The Proposals

Carpionato Group: Parcels 2, 5, 6

Post Road Residential: Parcel 5

Spencer Providence: Parcel 2 and 5

Urban Design Considerations

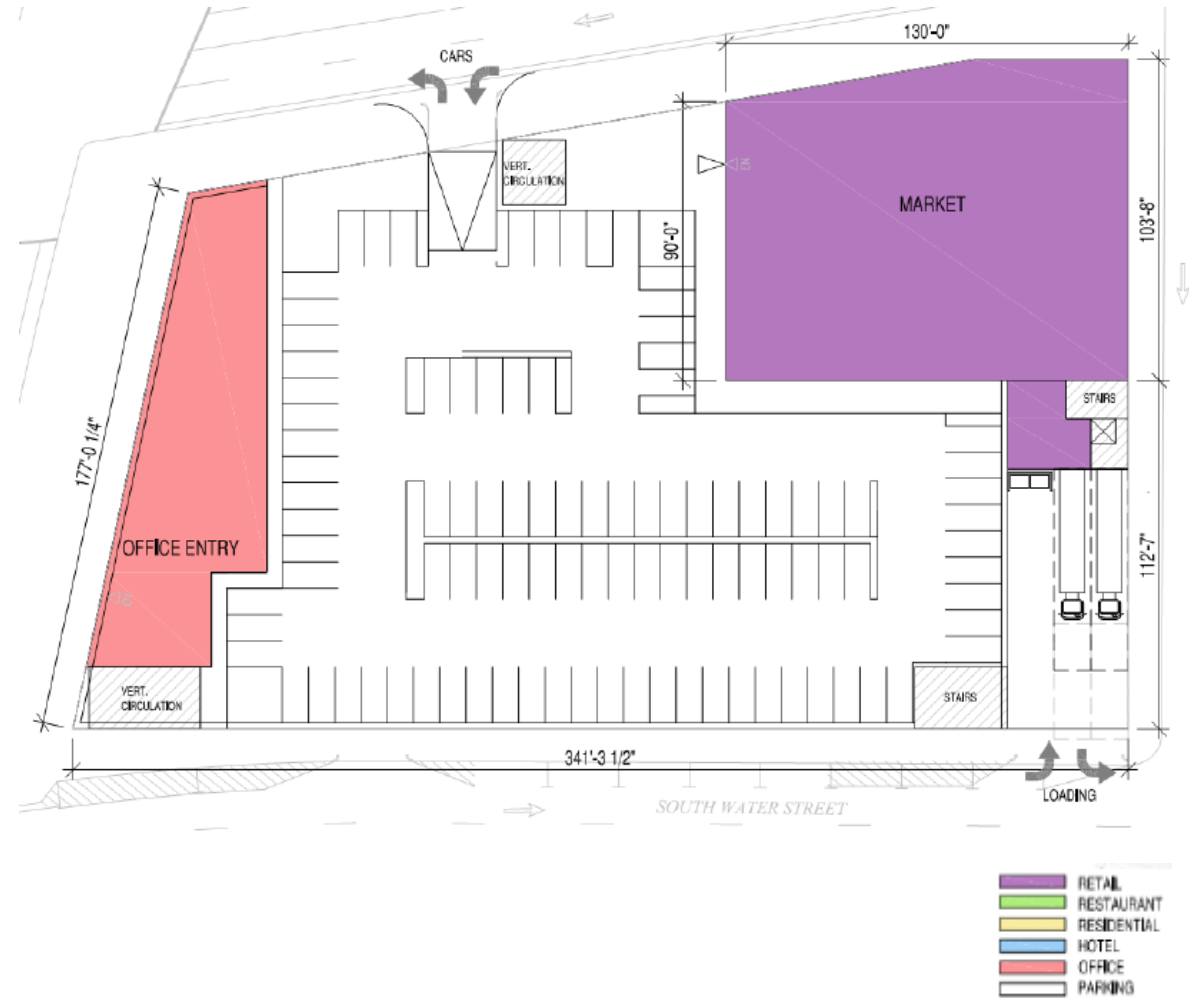
- Office lobby is not the highest and best use for Wickenden St. frontage of Parcel 6
- Pike St. is not the highest visibility location for market
- Consider moving the market to Wickenden St. and reconfiguring the office lobby to have a much smaller frontage on Wickenden St.

Building Design

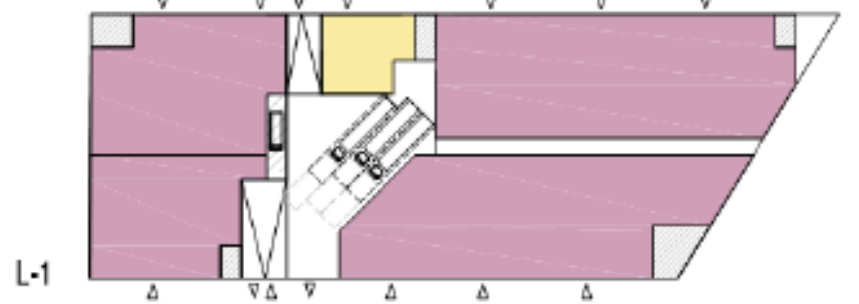
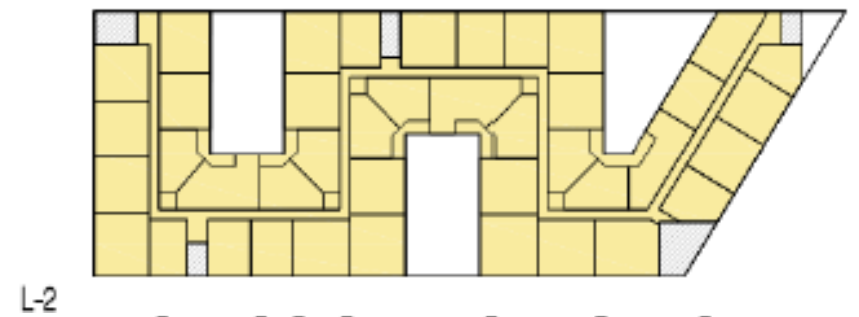
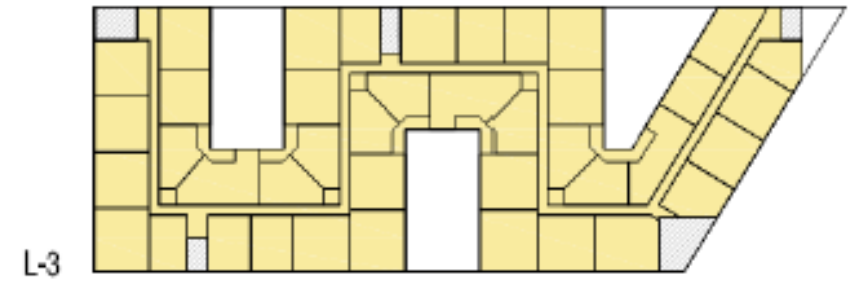
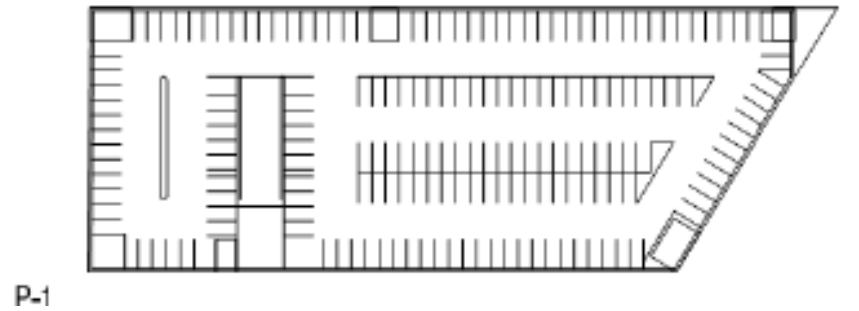
Residential program requires more design thinking:

- Snaking hallway results in an unusually high number of inside corners, creating awkward triangular corner units with a small amount of frontage on a window wall
- Circulation cores have been located on the outside corners of the building, using the most valuable space for egress instead of residential units

Building Design

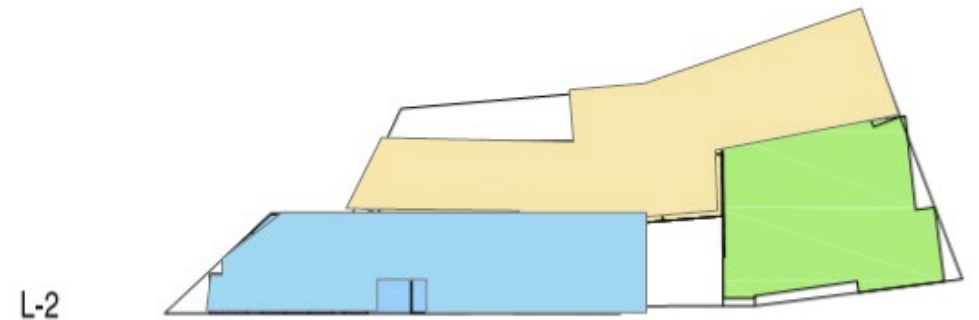
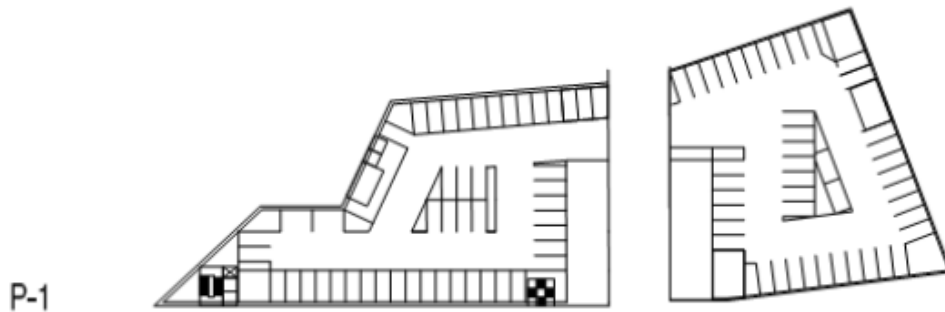
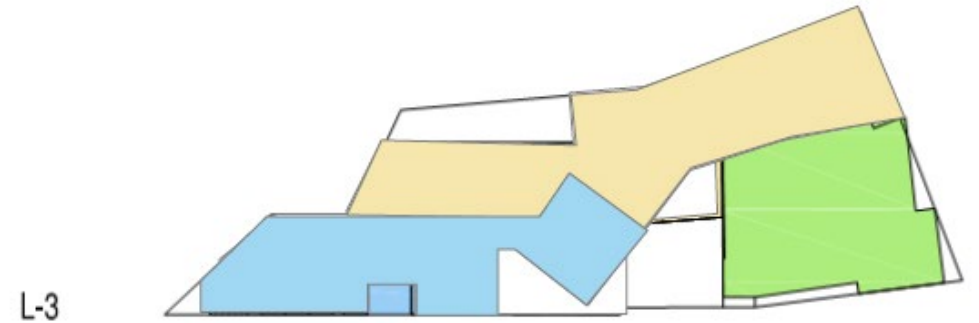
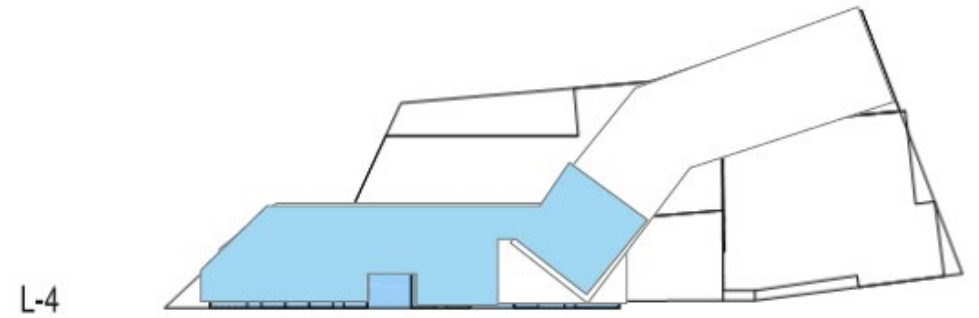
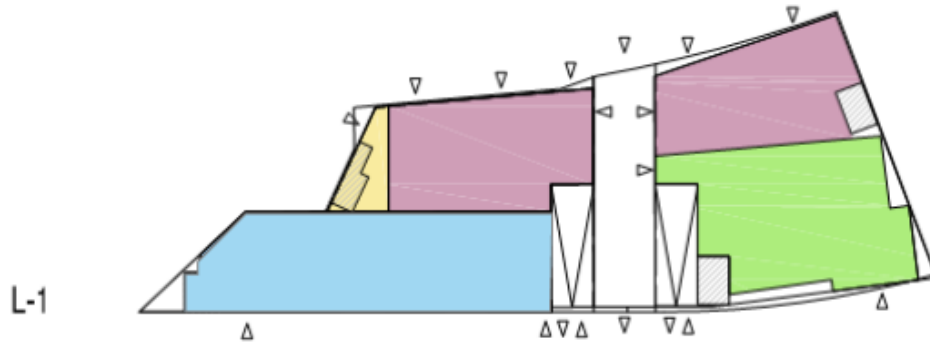
Upper floors of Parcel 2 do not look viable from a dimensional perspective. Submission is missing following key information:

- Vertical circulation for south building
- Horizontal circulation
- Hotel room layouts
- Residential unit layouts

Parking: Strategy & Zoning

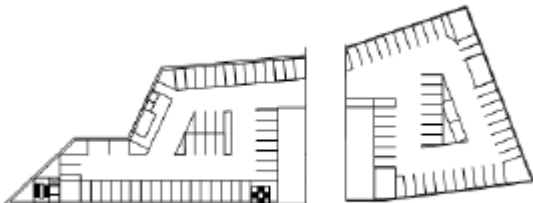
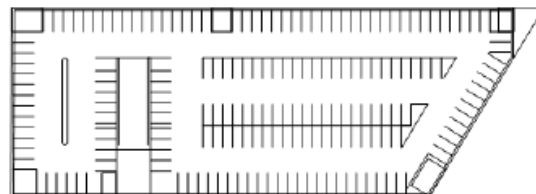
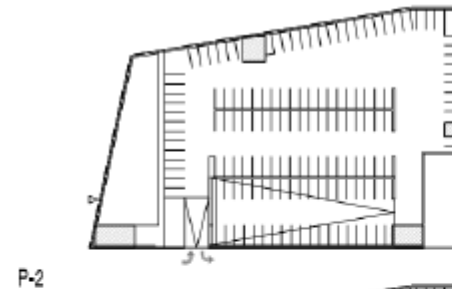
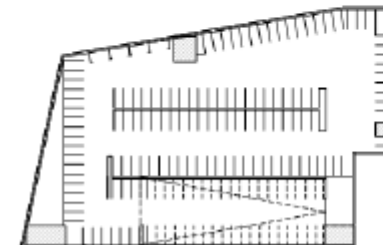
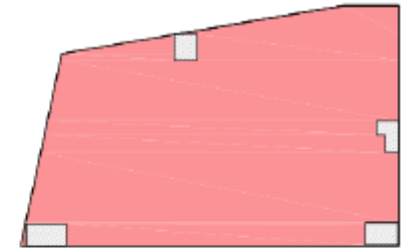
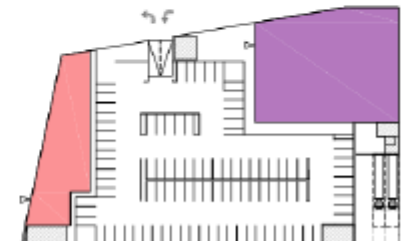
- Parcels 2 and 5 each have one level of underground parking
- Parcel 6 has three floors of parking, two underground
- Underground parking adds significant cost to a development and may not be financially supportable given the density of development program
- The underground parking facility on Parcel 2 is actually two separate garages due to the utility easement, which increases costs as well
- Parcels 2 and 6 do not meet parking requirements
- Citywide requirements are high for such a walkable, urban location, and DDRC will likely be willing to relax them

Note: drawing shows 372 spaces for P6.

Urban Design Considerations

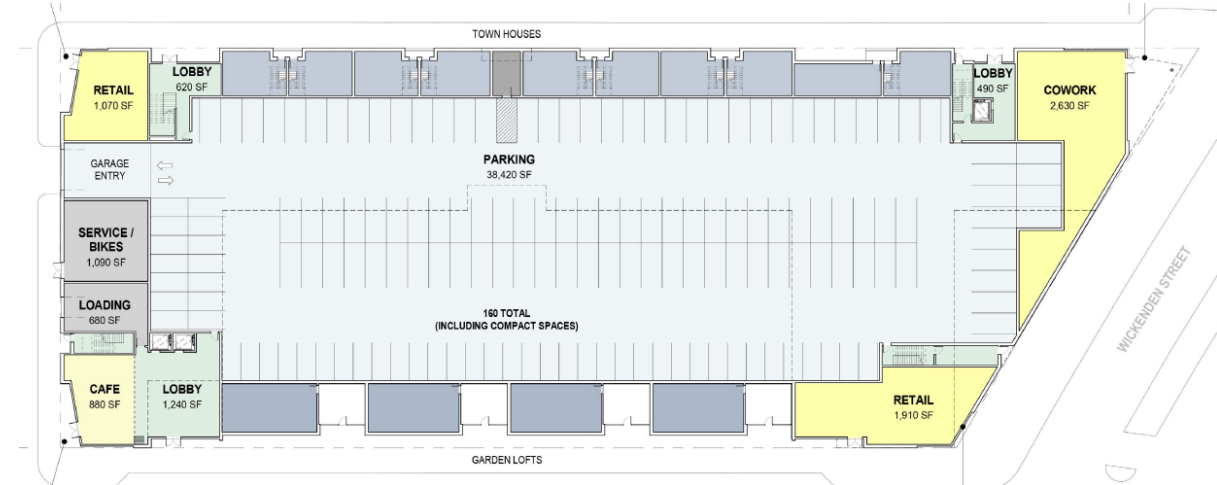
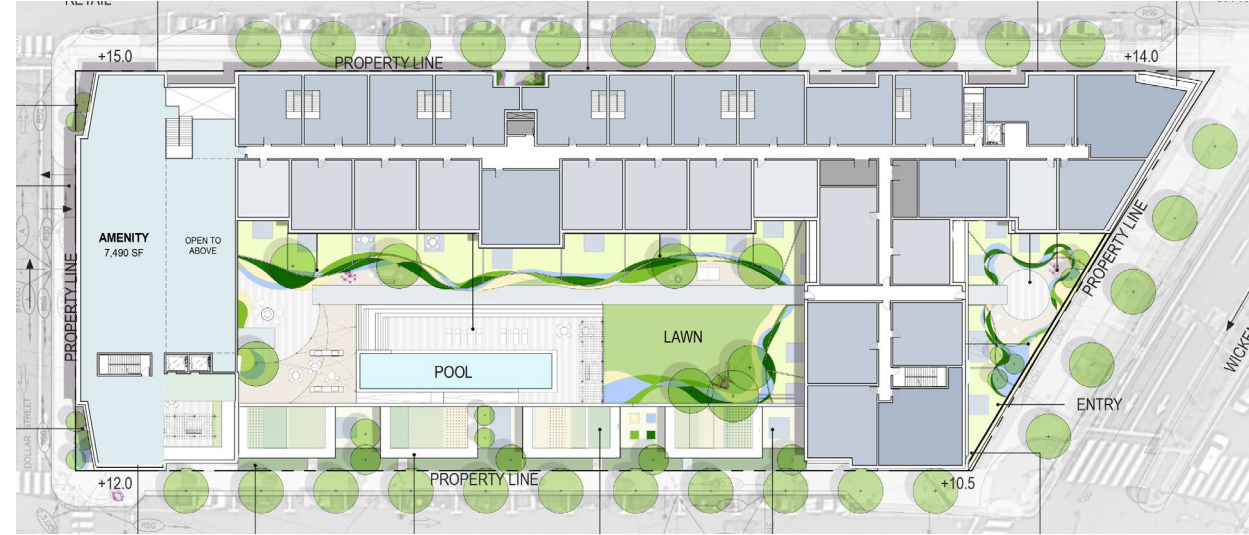
- Active uses at all the corners, which are the highest-value spaces
- Realistic expectations about retail demand
- Co-working may not be the most active use for Wickenden St. corner
- South Main St./Dollar St. corner is not the highest traffic retail location
- Consider switching the location of those program elements

Building Design

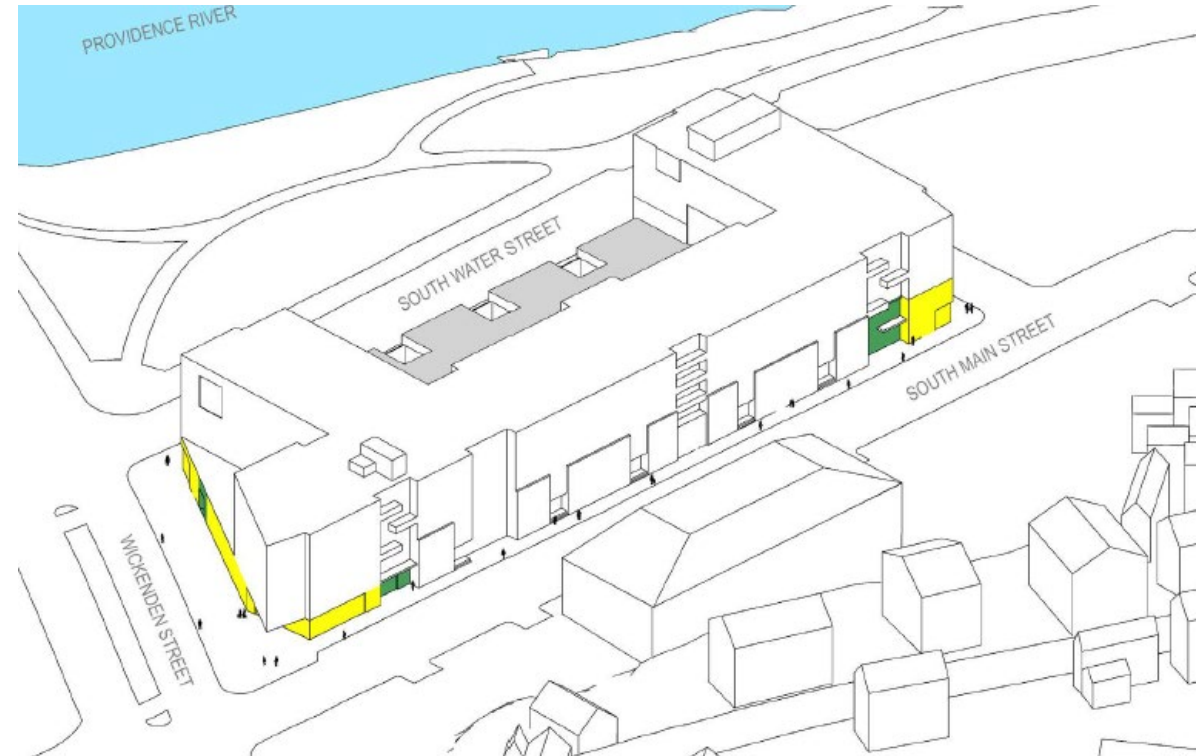
- Experienced architectural team that will need to up their game to meet quality expectations
- The renderings show a promising direction for the buildings along South Main St.

- Long façade along South Main St.; design elements should be introduced to visually break up the massing
- Unit layout and mix demonstrates experience with residential buildings

Parking

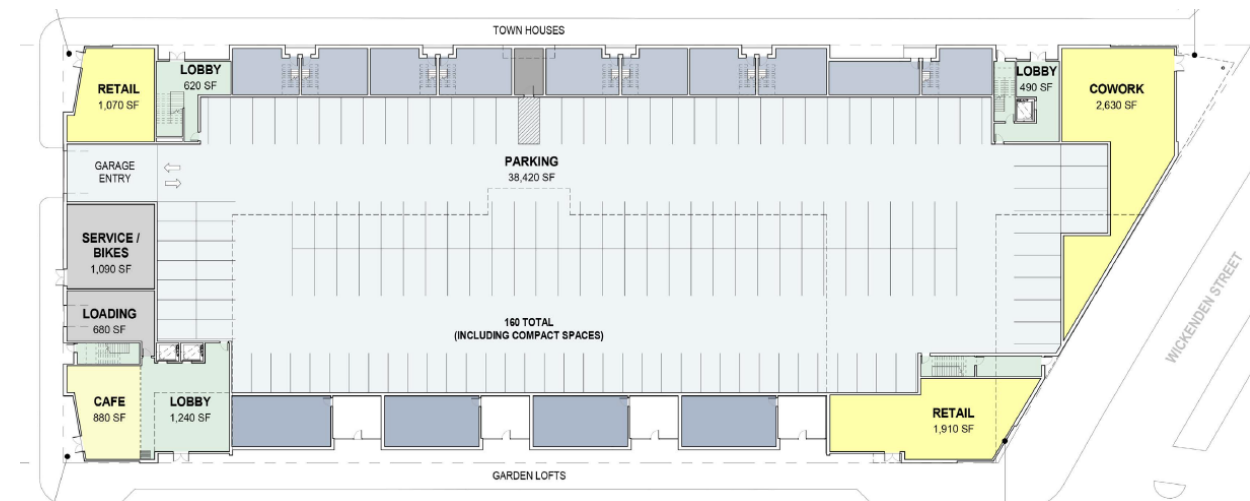
- Proposal includes nearly the amount of parking required; DDRC will likely grant a waiver because the citywide parking requirements are high for such a walkable, urban location
- One of two possible waivers results in sufficient parking:
 - Parking requirement is waived for retail and co-working uses, or
 - Residential requirement is reduced from 1 space/unit to .9 spaces/unit
- Either of these changes also removes need for tandem spaces and enables a slightly larger, rationalized co-working space
- There are also 53 on-street parking spaces on South Main St. and South Water St., more than enough to serve the retail and co-working
- Parking provided is satisfactory for market demand

Note: drawing shows 156 spaces (incl. 22 tandem).

Urban Design Considerations – P2

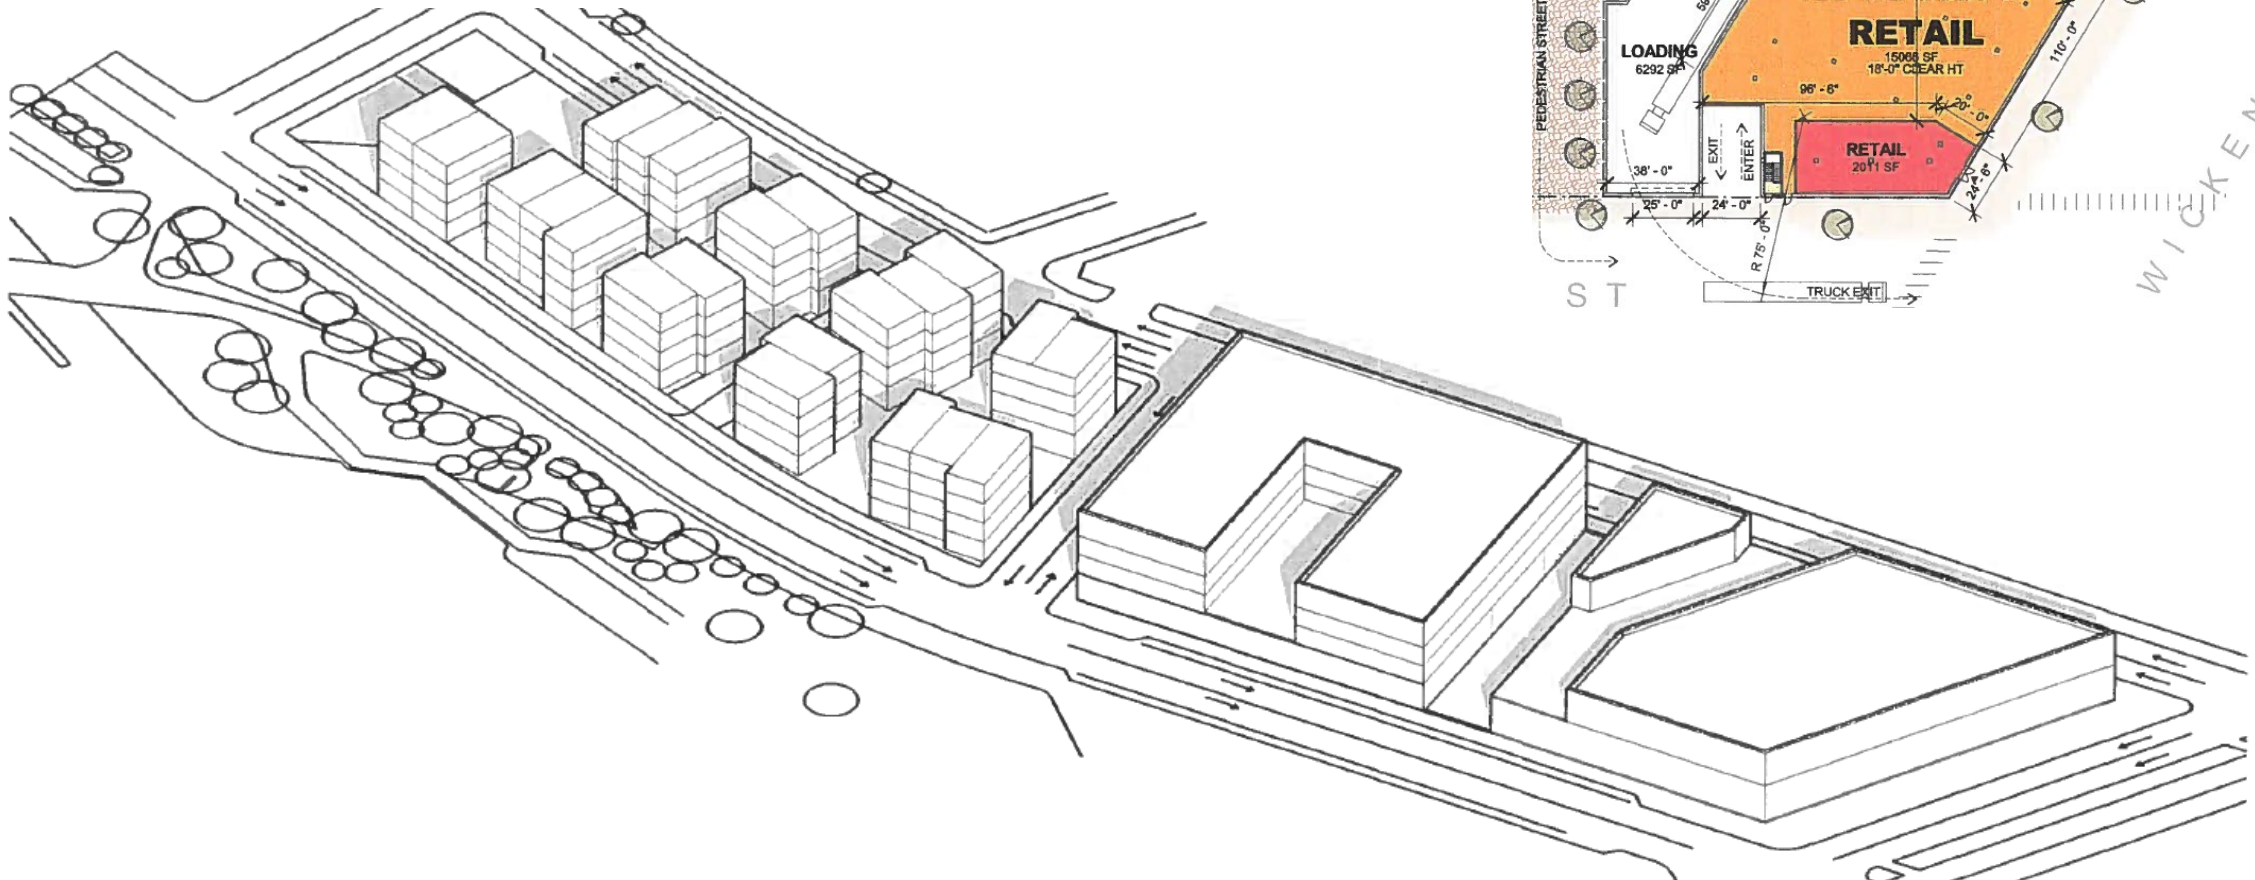
- Original proposal had purely private uses at the foot of the new pedestrian bridge, which would not make the most of the significant public investment; revised version proposes retail ground floor for some townhomes, but it's unclear if that is viable from a market and/or management perspective
- Need to understand and consider specifics of retail plan since it will have significant impact on urban design approach

Parking: Strategy

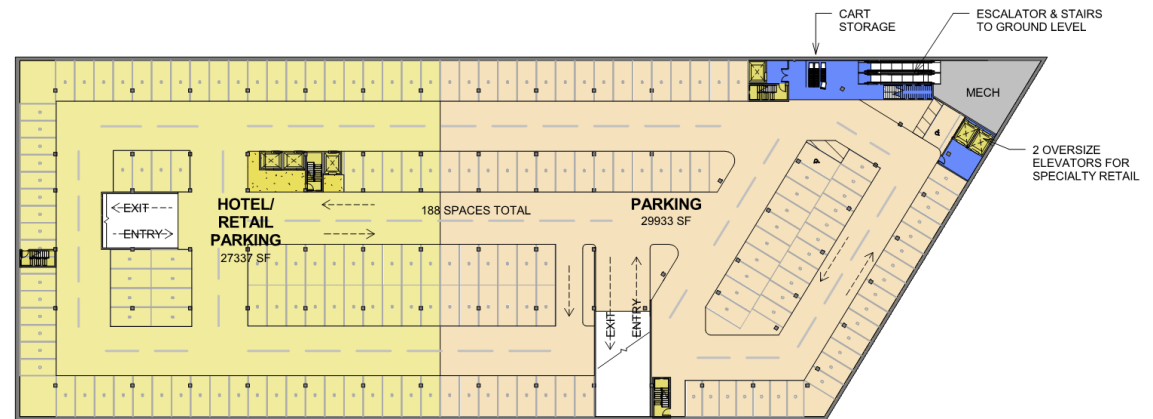
- Parcel 2 townhouses have 2 tuck-under spaces each
- Parcel 5 has a single floor of underground parking, totaling 188 spaces
- There are 103 on-street spaces on South Main St. and South Water St. with no competing uses, which can also support retail uses
